New Cummins Feature will be STANDARD for NYBS Service Update #18-0307

Diesel Particulate Filter (DPF) Temperature Stabilization

TSB170058

Aftertreatment Diesel Particulate Filter (DPF) Temperature Stabilization Feature

Figure 1, Aftertreatment Diesel Particulate Filter Temperature Stabilization Feature

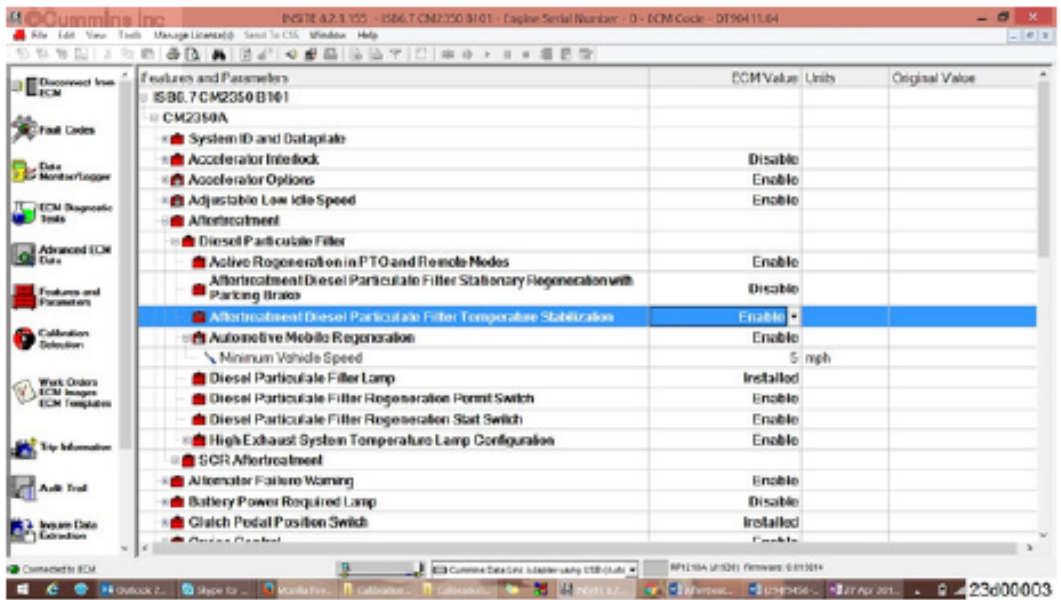
- The Aftertreatment Diesel Particulate Filter Temperature Stabilization feature is a user-selectable feature in INSITE™ electronic service tool. See Figure 1.

- When enabled, the Aftertreatment Diesel Particulate Filter Temperature Stabilization feature will change the start of regeneration threshold to be 0.6 mph above the Automotive Mobile Regeneration Minimum Vehicle Speed threshold versus the 40 mph standard start of regeneration threshold. The Aftertreatment Diesel Particulate Filter Temperature Stabilization feature will also allow the system to inject low amounts of fuel to keep the aftertreatment DPF warm when the vehicle speed drops below the Minimum Vehicle Speed threshold. This prevents the regeneration from aborting and allows the regeneration to continue once the vehicle speed exceeds the Minimum Vehicle Speed threshold.
